Siemens Technical Action Bulletin No.	STAB19-0116
--	--------------------

<u>TITLE</u>	Pushbutton change on Siemens Mk1 Nearside Signal & Wait Indicator Units
---------------------	--

Figure1: New Pushbutton for Mk1 Nearside Units

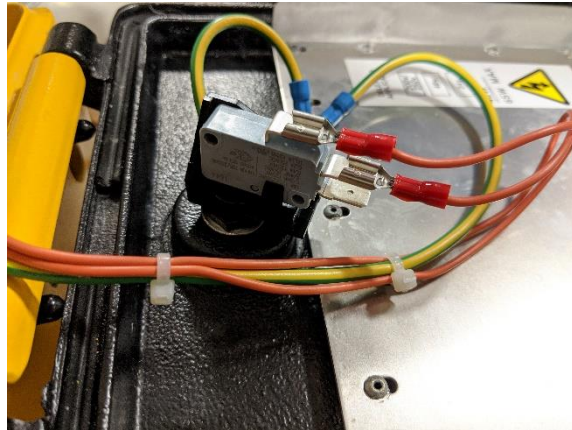
Due to supply issues with the current replacement microswitch kit 667/4/04719/001, the pushbutton in this kit has now been replaced with a new design.

This means that, from December 2019 onwards, the existing part number **667/4/04719/001** for the Mk1 pushbutton replacement switch kit will now call up the new pushbutton (as shown in *Figure1*).

The new pushbutton has a plastic body so there is no longer a requirement for the earth link from the door to the switch. However, if preferred, the earth link to the switch body may still be installed as per existing switch (as shown in *Figure1*).

Apart from this, there are no other changes to the wiring or connections on the new switch, so please continue to wire as per the original switch.

When retrofitting the new replacement switch, care must be taken to avoid cross threading the plastic threads on it.
